DEVELOPMENT REVIEW BOARD REPORT

CASE NUMBER/ PROJECT NAME	30-DR-2005 AG Medical Plaza		
LOCATION	3310 N Scottsdale Road, northwest corner of Scottsdale Road and Angus Drive		
REQUEST	Request approval of site plan and elevations for construction of a 3-story medical office facility and underground parking.		
OWNER	G & G Development Companies 480-570-0244	ENGINEER	N/A
ARCHITECT/ DESIGNER	P/ D Architects 480-970-8747	APPLICANT/ COORDINATOR	Kent Dounay P/ D Architects 480-970-8747
BACKGROUND	<p>Zoning.</p> <p>The site is located at the northwest corner of Scottsdale Road and Angus Drive and is zoned C-3 (Highway Comm.) District where retail, offices and medical offices are permitted. The site is situated outside of the Downtown District/ Overlay.</p> <p>Context.</p> <p>The site is located southwest corner of Scottsdale Road and Angus Drive.</p> <p>Adjacent Uses:</p> <ul style="list-style-type: none">• North: Red Lobster and Olive Garden Restaurants with C-3 zoning.• South: Angus Drive and the US Egg Restaurant with C-3 (Highway Comm.) District zoning.• East: Scottsdale Road and a hotel toward the east with C-3 DO zoning.• West: N. 71st Street and apartments and single-family homes wit

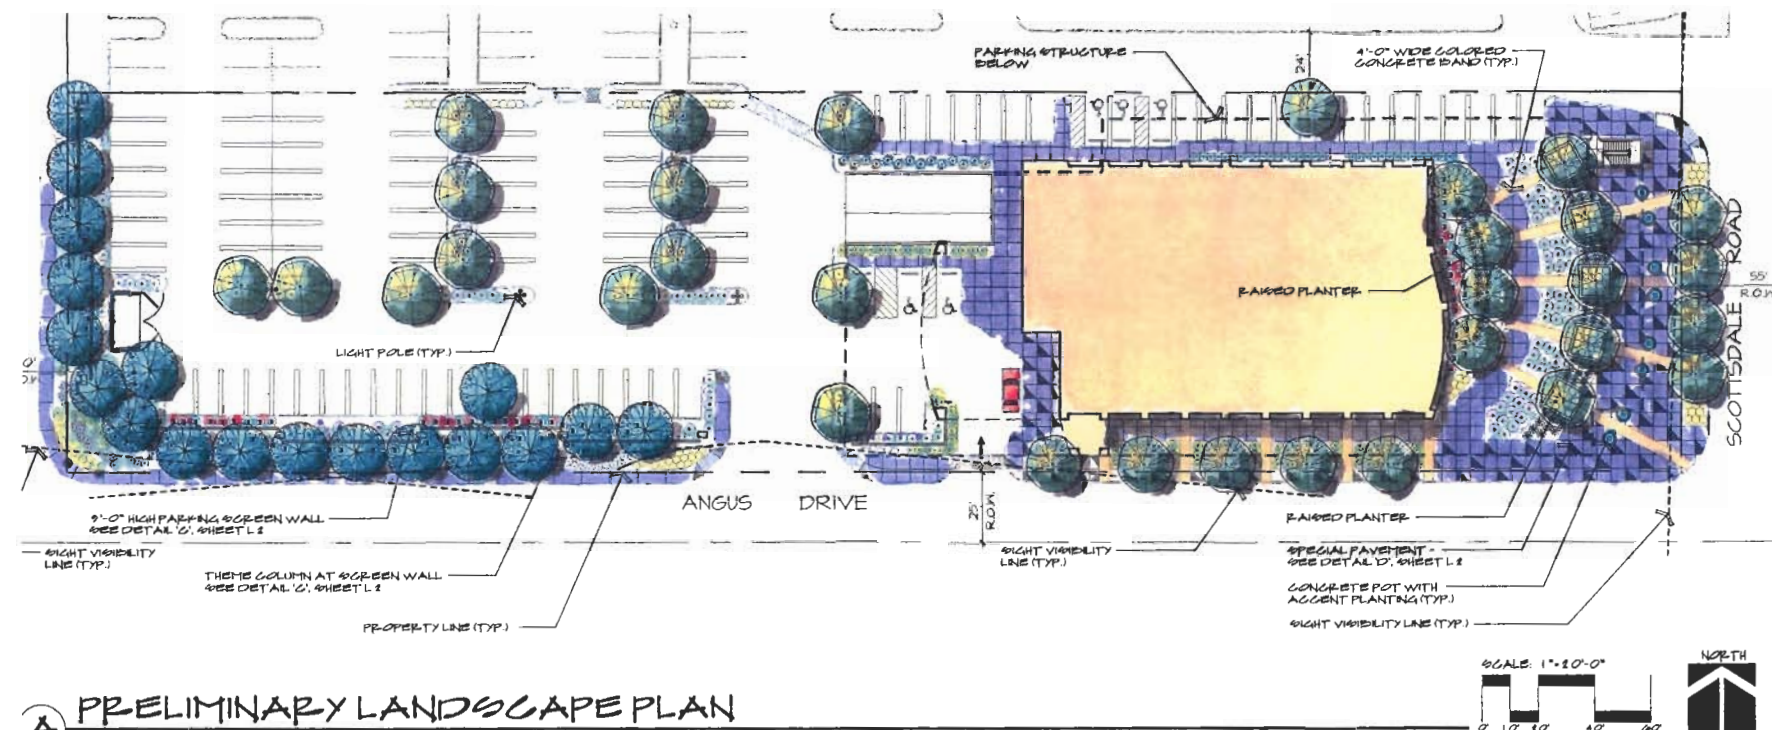
26. The developer shall provide a drainage report for this development. The post development drainage plan shall be to drain the entire site to the existing storm drain on Scottsdale Road via an underground pipe system, not surface drainage. It is permissible to eliminate the above ground retention basin in the southwest corner of the site.

34. The developer shall provide a minimum parking-aisle width of 24 feet.
35. The developer shall provide internal circulation that accommodates emergency and service vehicles with an outside turning radius of 45 feet and inside turning radius of 25 feet.

40. Refuse enclosure is far from building – should be moved closer.
41. Enclosures must:
- a. Provide adequate truck turning/backing movements for a design vehicle of turning radius R (minimum) = 45 feet vehicle length of L = 40 feet.

ATTACHMENT #5

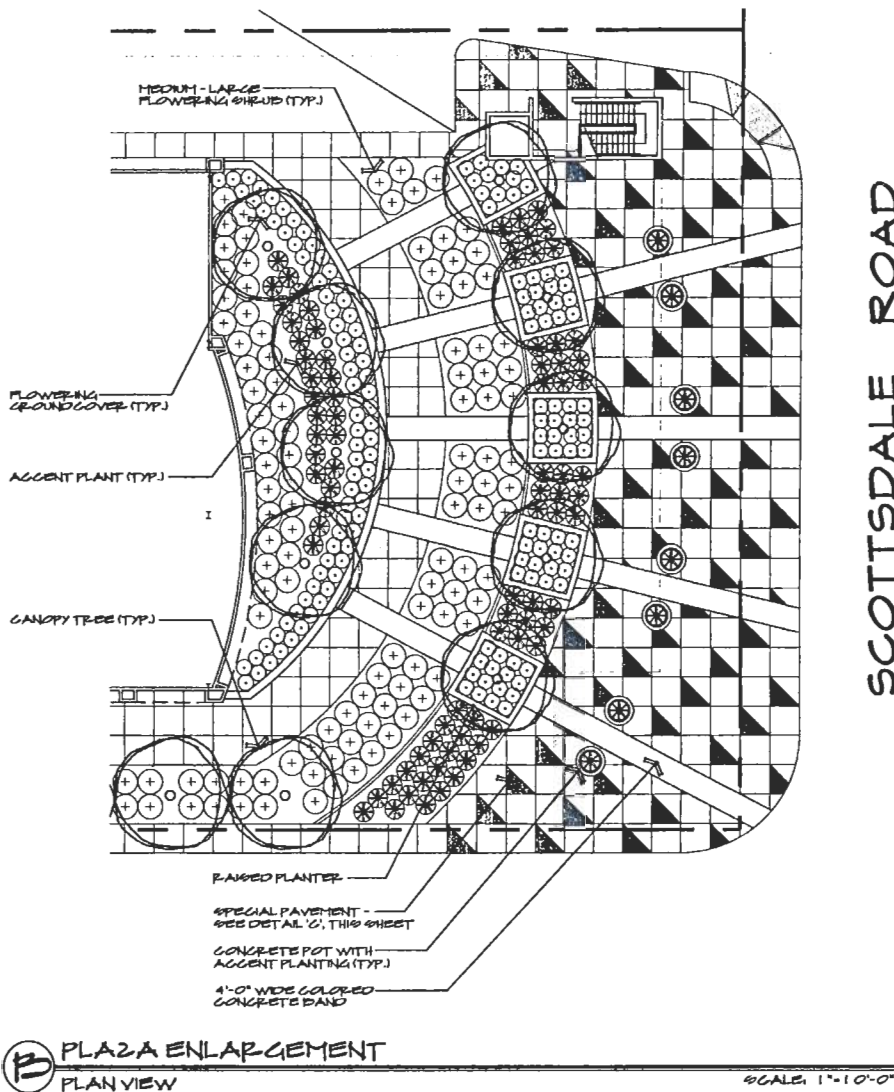
14. Shrubs, ground covers, and succulents within a site visibility triangle shall be solely selected from species that have a maximum regional growth habit not exceeding 2 feet. Site visibility triangles shall be applied at the intersection of all public streets abutting the site and the intersection of site driveways with public streets. Site visibility triangles shall be as defined by the most recent draft of the City of Scottsdale Design Standards and Policies Manual existing at the time of hearing on this application.

15. Box size for mature trees shall be adequate to meet industry standards (Arizona Nursery Association) for the required caliper size. If the necessary box size is not listed or available, specimens shall be purchased meeting the minimum caliper requirement.
